Space House

Planning and Listed Building Consent Substitution Pack

For London Borough of Camden

Detail Section of Proposed Tower Extension - showing previously submitted roof height and balustrade position

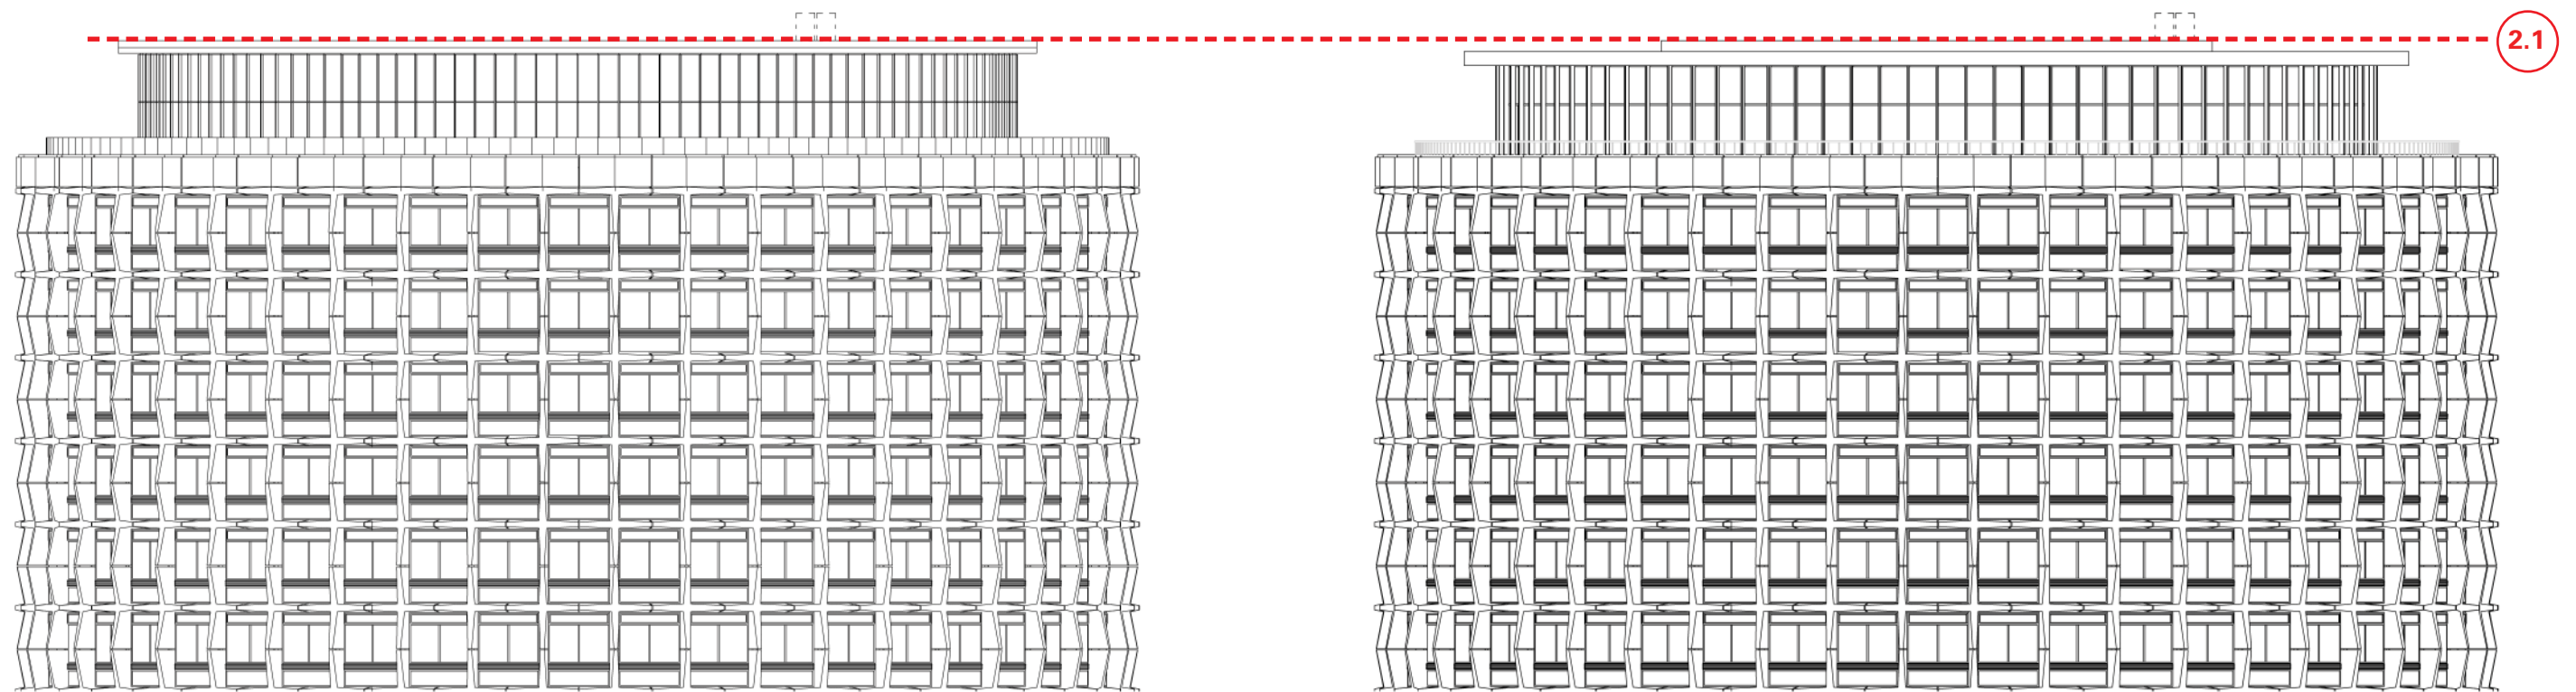
2.1 Lowering the height of the setback floor (level 17) by 400mm to reduce the proposals impact in long views and adjust the proportions between new and old. The plant enclosure which sits in the circular core of the 17th floor will remain at the previous height but will be barely visible at distance on account of how far set back it is from the main roofline.

2.2 Thickening the roof 'cap' and increasing the projection of the roof overhang to define the building termination. Detail and proportion of the roof edge draw reference from the existing roof 'cap' and from other Seifert & Partners built projects.

Revised Proposed balustrade detail showing height, setback and material

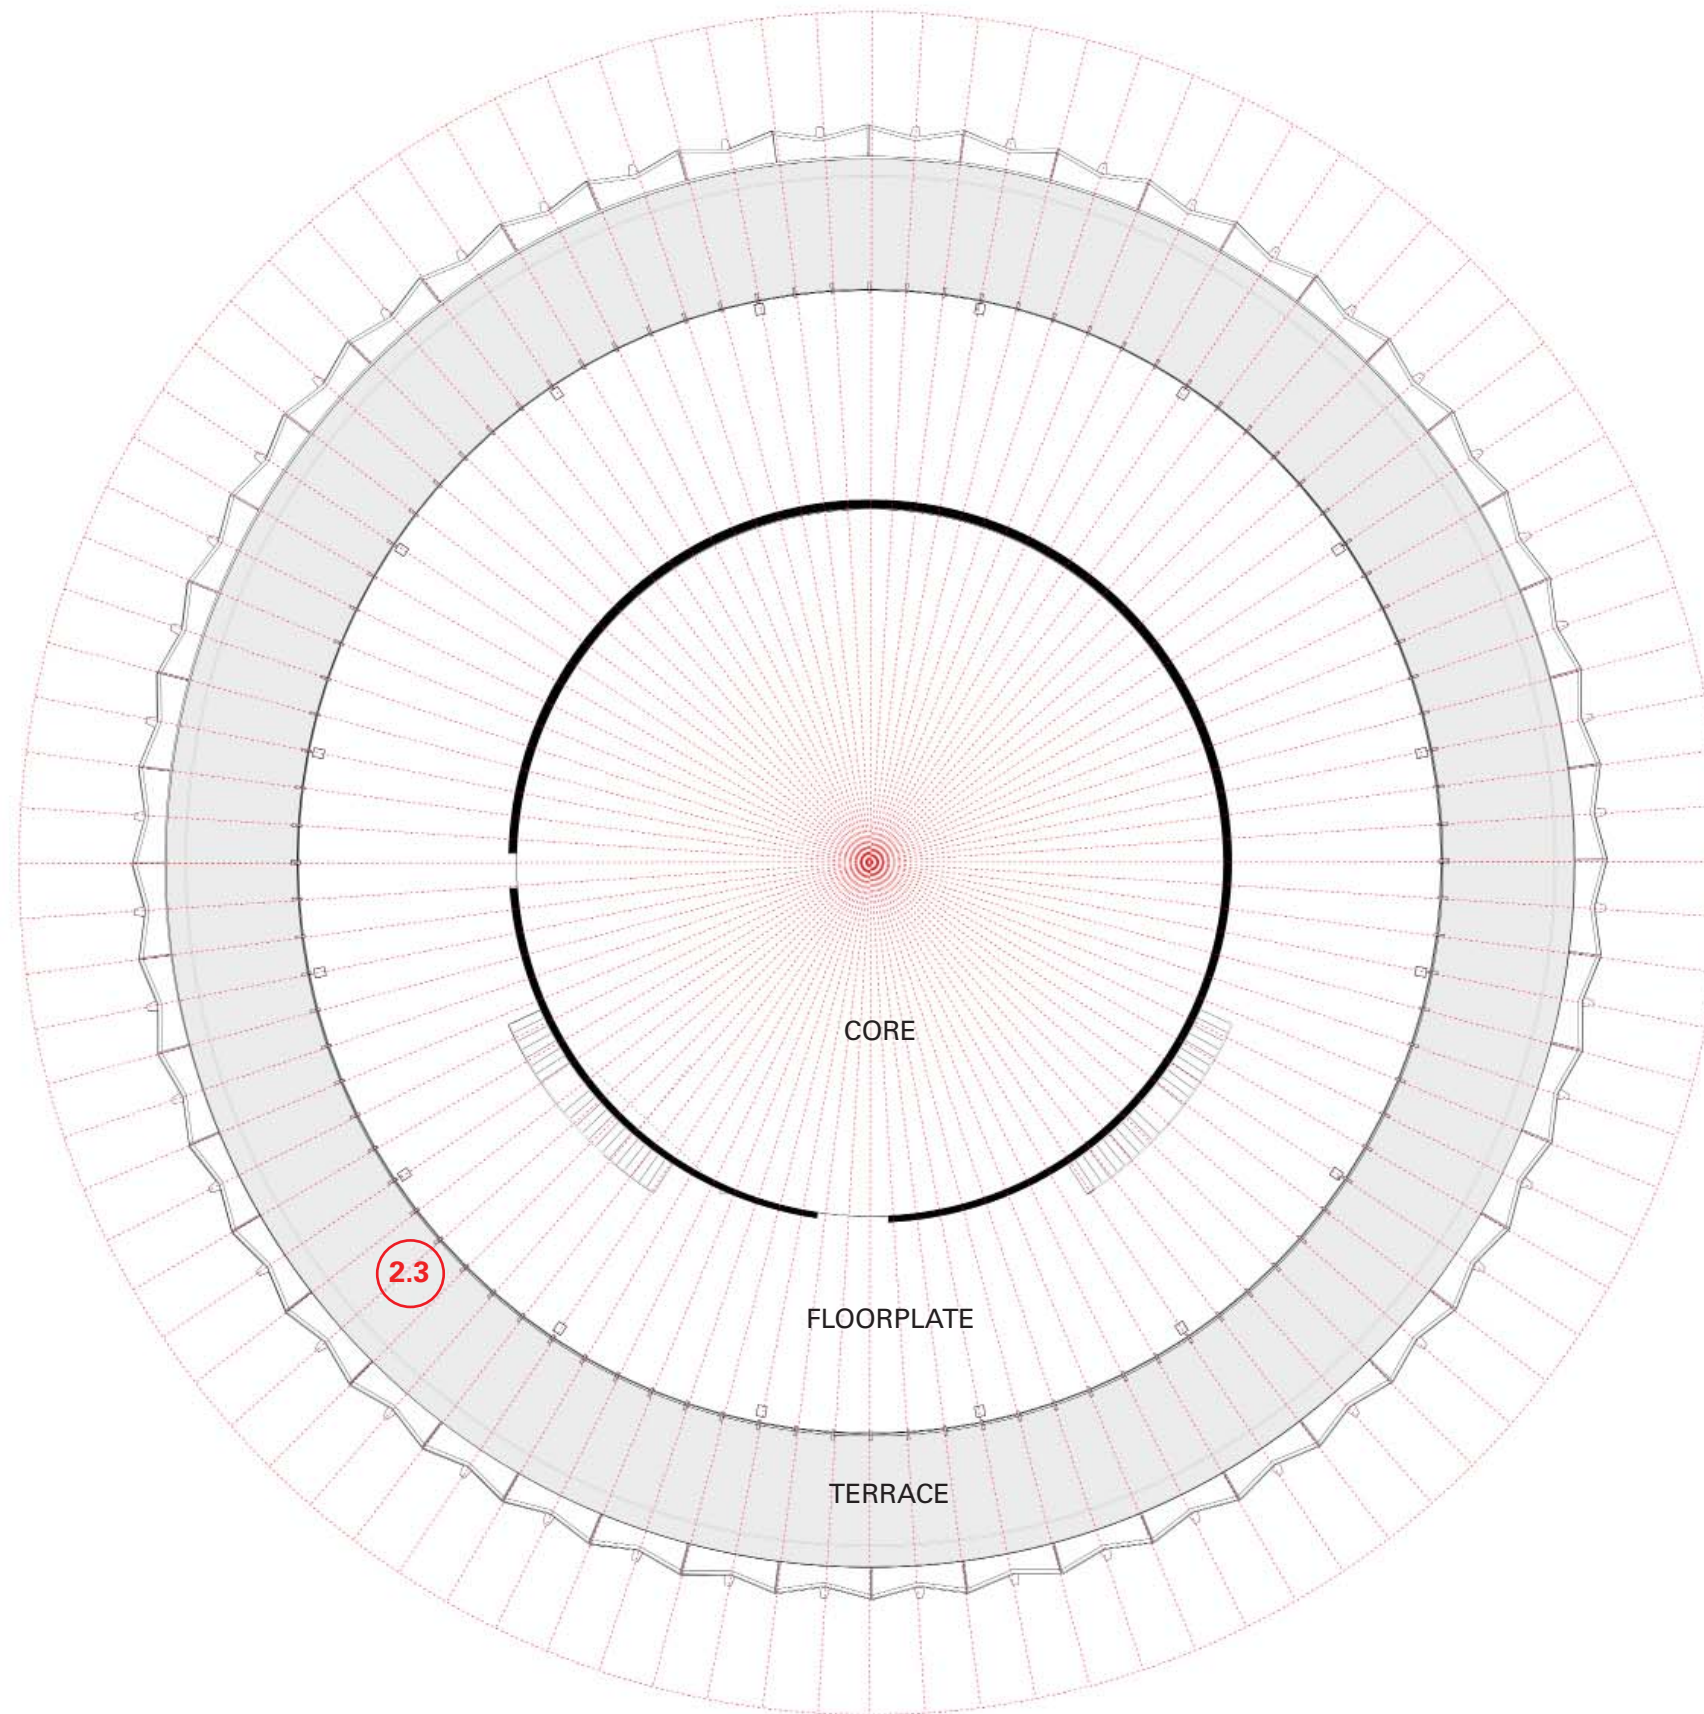
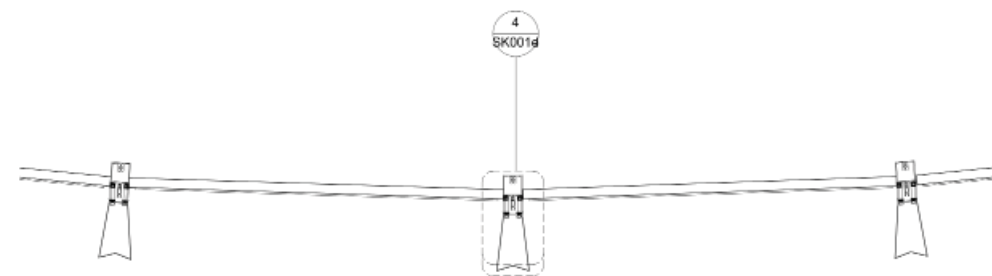
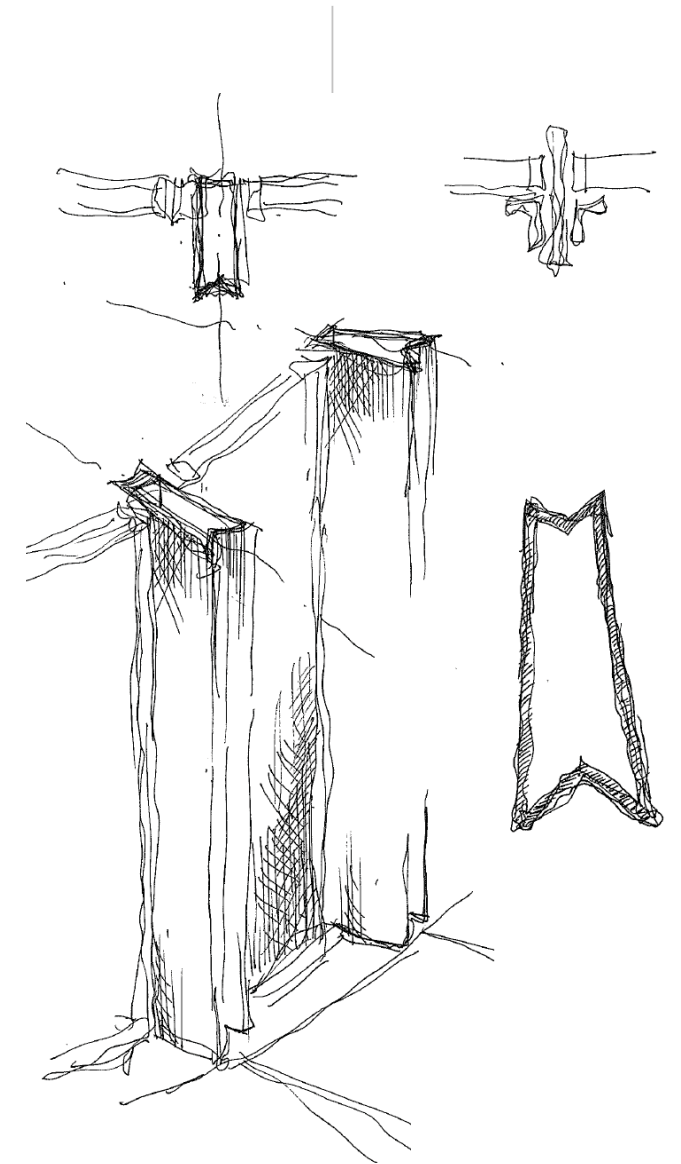
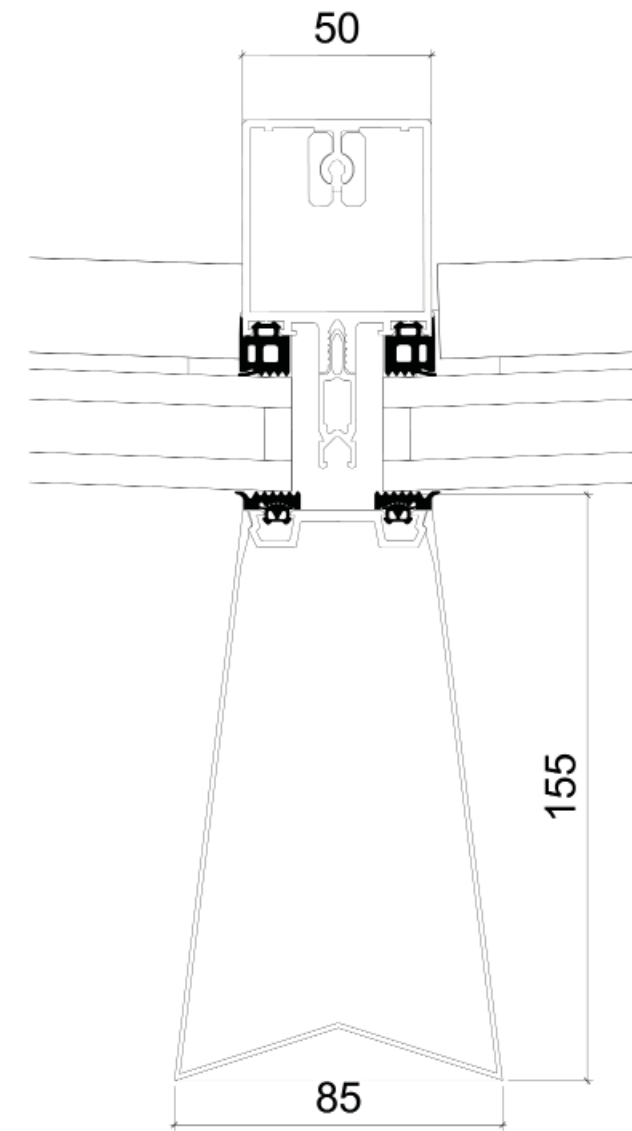
2.4 Balustrade has been further setback by 350mm and material changed to steel metal rods with a top flat bar in a PPC finish to match the aluminium framing of the windows

Diagram illustrating how the revised proposed setting out of glazing to level 17 has been driven from listed building below

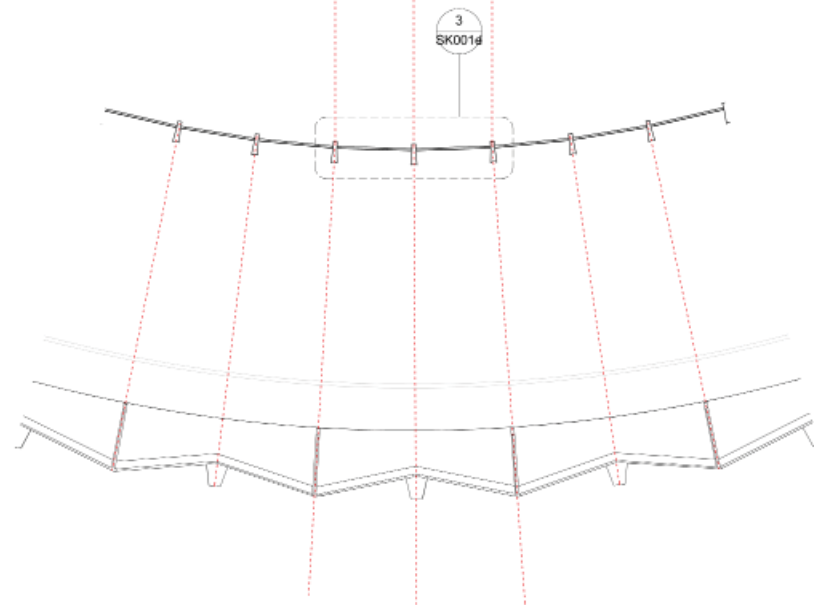
2.3 Further detail added to the new window mullions on the setback floor. The 'bowtie' cap given to the mullions will draw reference from the geometries of the listed building fabric below and increasing the depth of the reveal will give a hierarchy between the mullions and the glass. The mullions will be aluminium in a colour match to the existing aluminium windows.

Proposed section

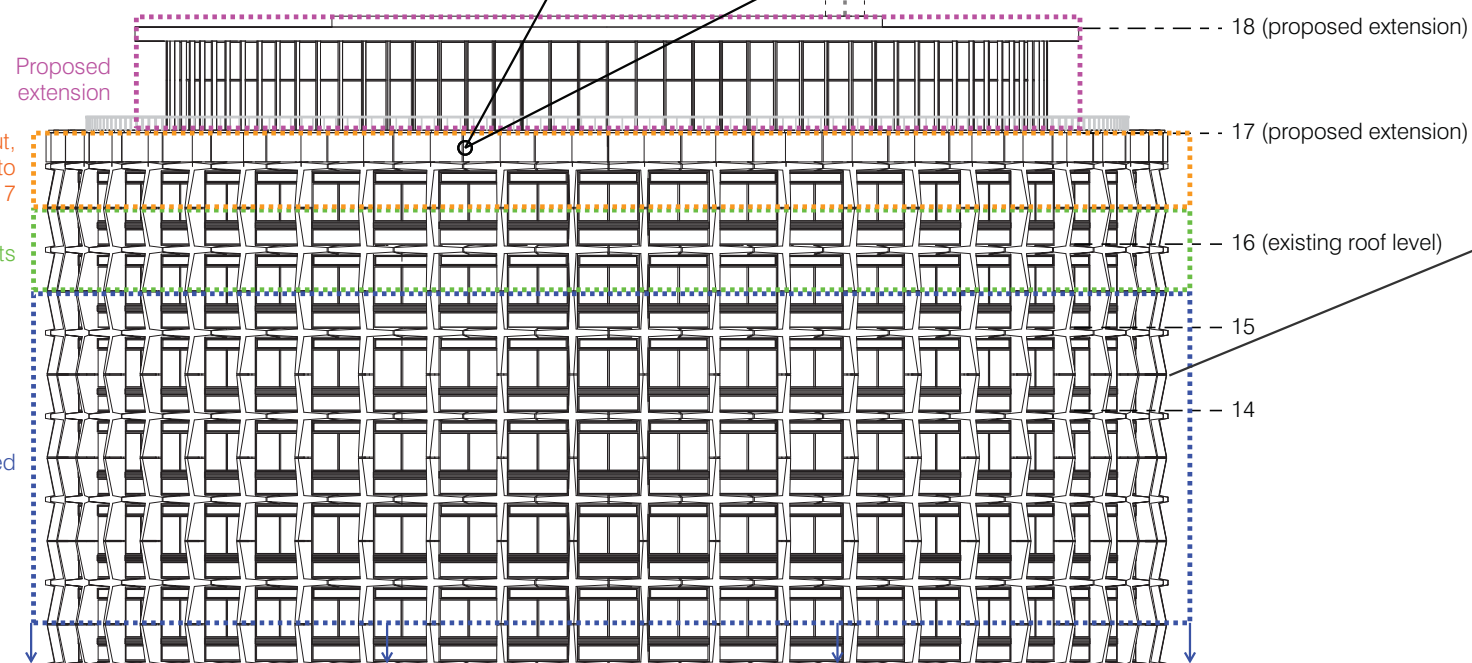
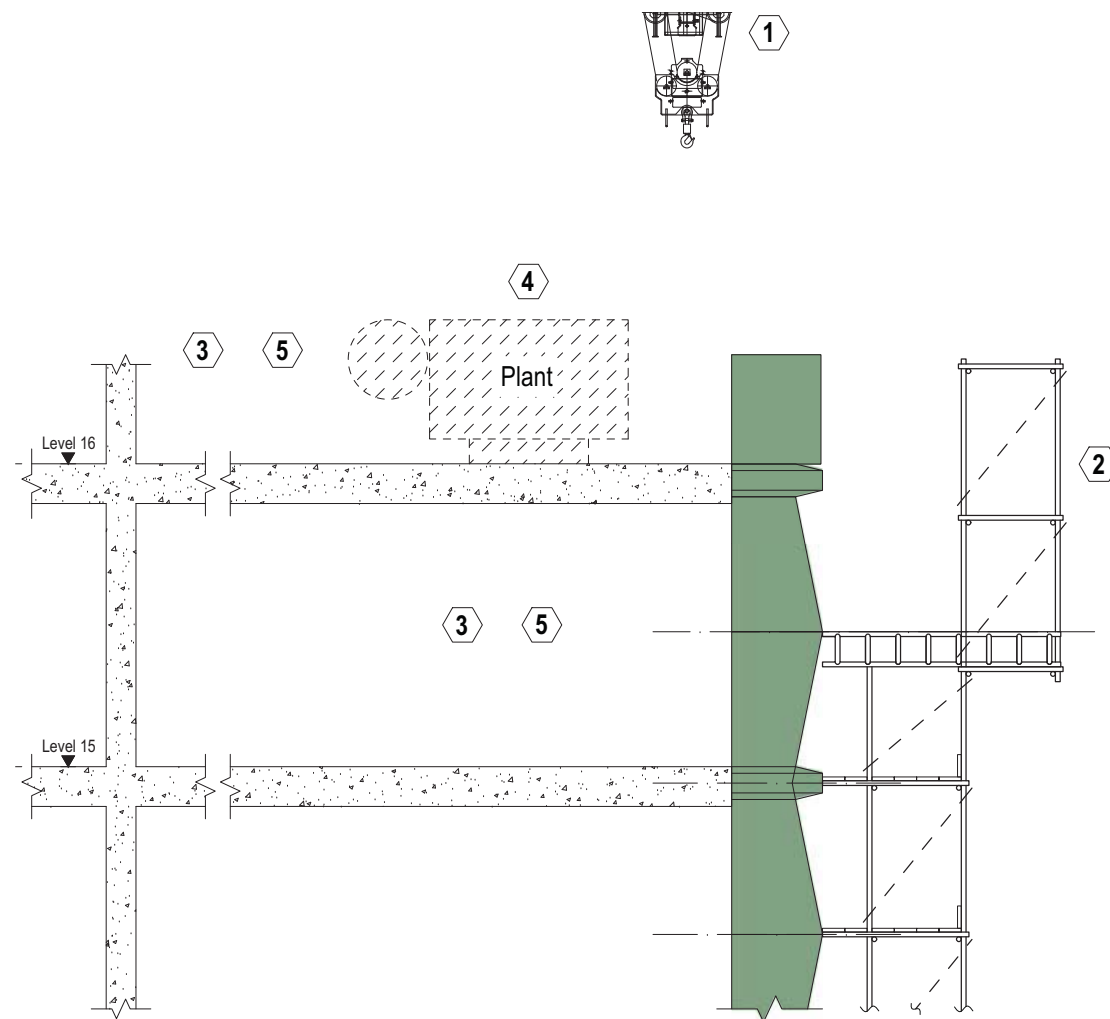
2.5 Listed fabric is retained in creating the 'facsimile floor'. The applicant has undertaken lengthy discussions with both the original structural engineers, Pell Frischmann and a respected temporary works engineer. A method statement for the proposal has been put together and included as part of this substitution pack. The applicant has also commenced discussions with PAYE to ensure the listed building is carefully cleaned and repaired where necessary during the refurbishment.

Precast T units cut,
retained and moved to
level 17
